Subject: RE: Application # 221287; 68 Forest Road, Mount Hermon

Memorandum

Subject: Replacement Residence at 68 Forest Road, Mt Hermon, Santa Cruz County.

Re: 68 Forest Road, Mount Hermon, CA 95041; APN: 066-241-06; Item # 2.221287

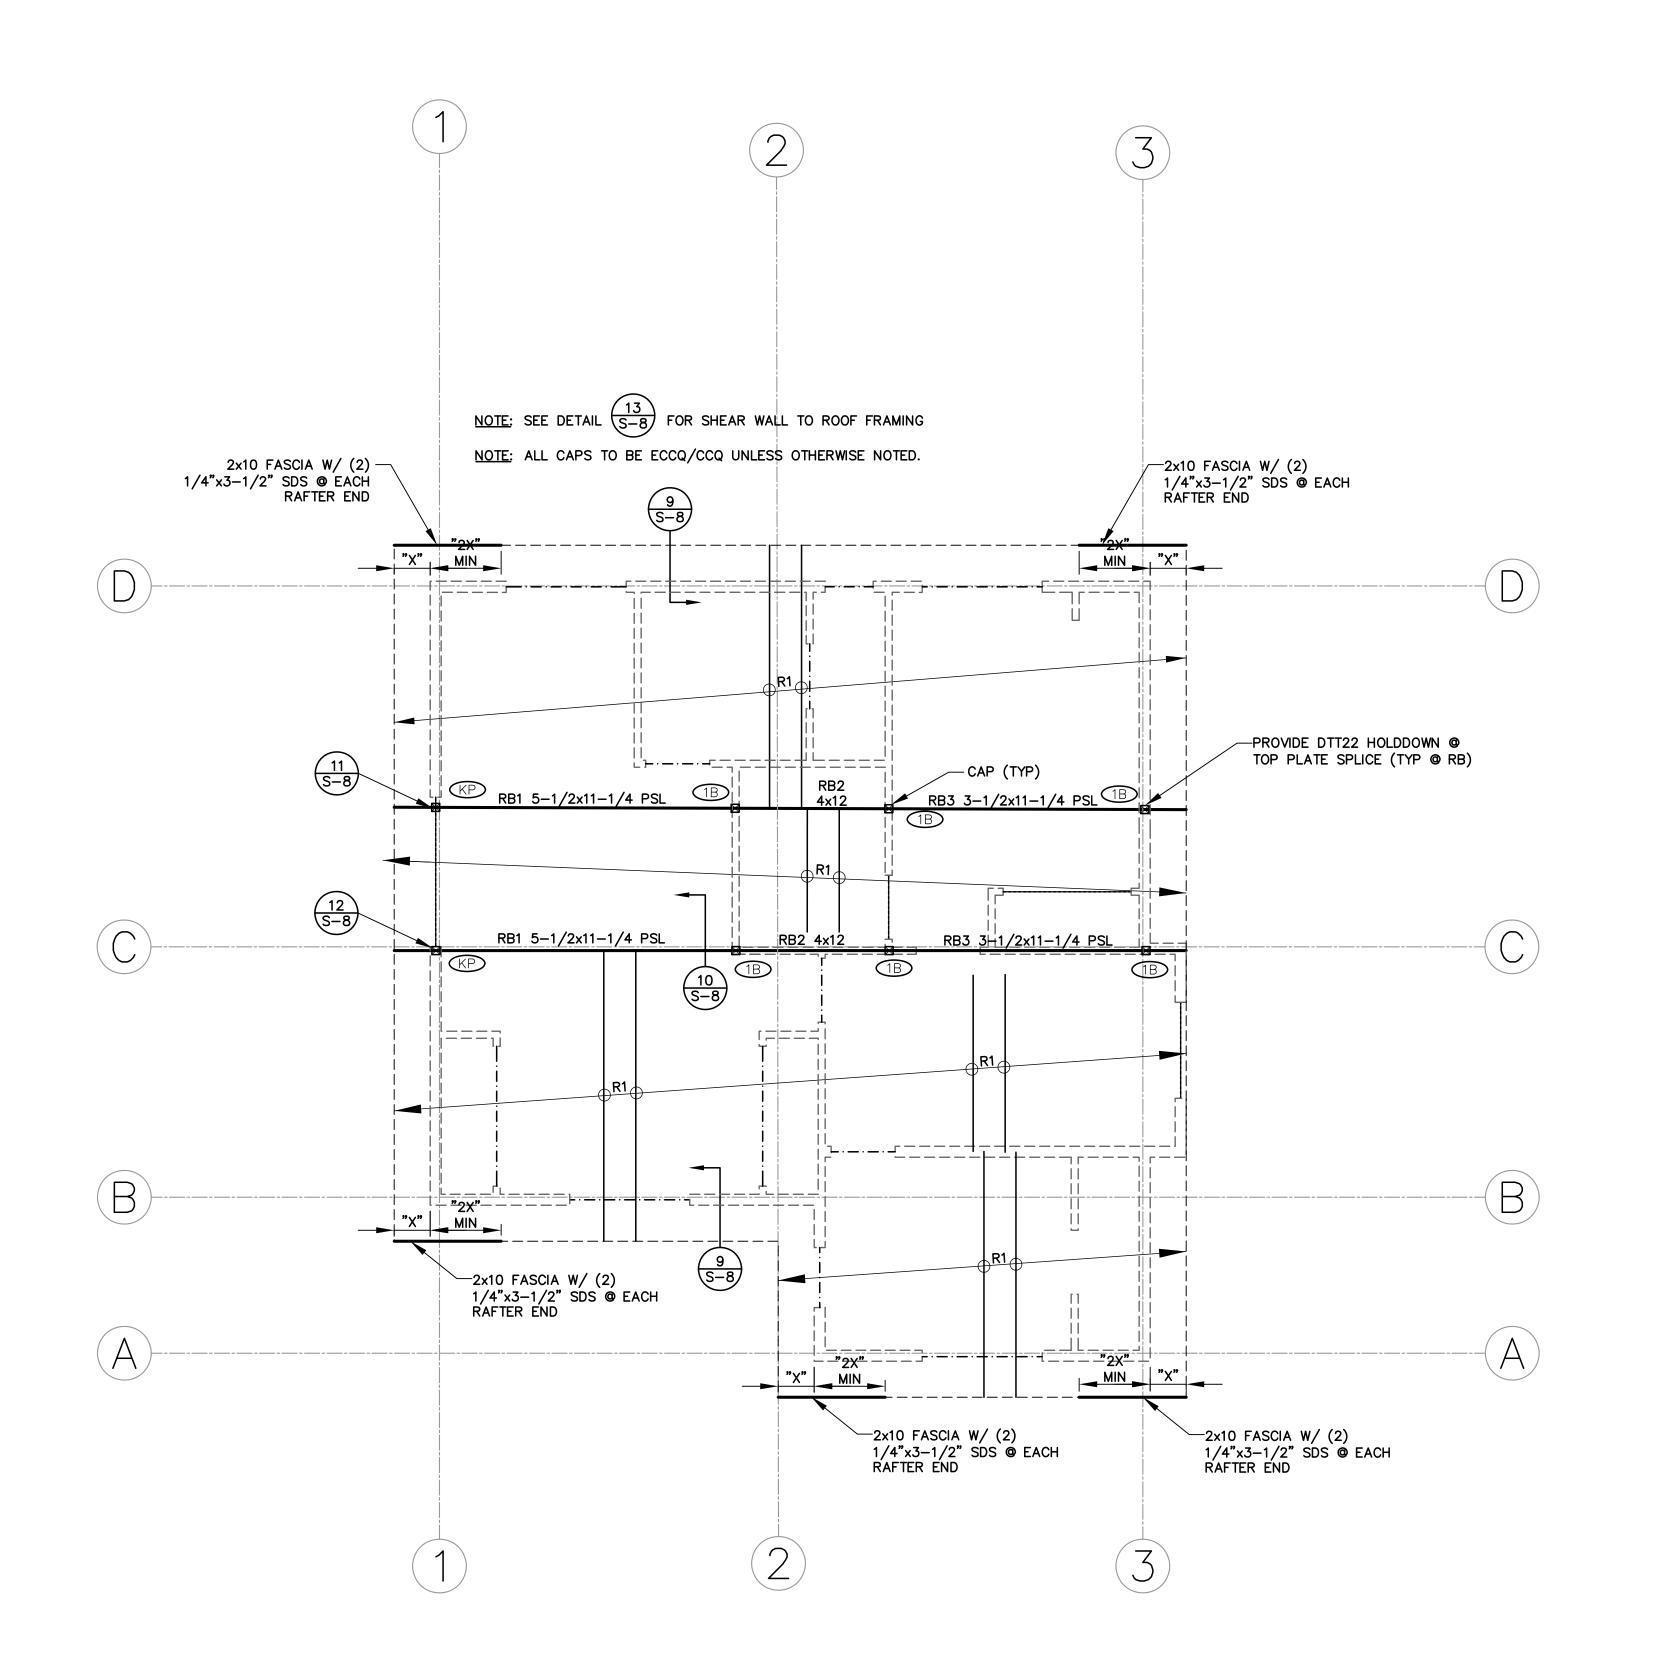
The proposed trellis shown on the structural engineering plans dated 9/7/2022 shows a pier support for the trellis located within the 5 foot side yard setback. This support is required to be located in the setback because of a required five foot set back from the septic system to structural supports. The site topography and limited space to avoid the septic system has created a need to place the trellis support in the side yard setback. The trellis will also add additional lateral support to the proposed deck.
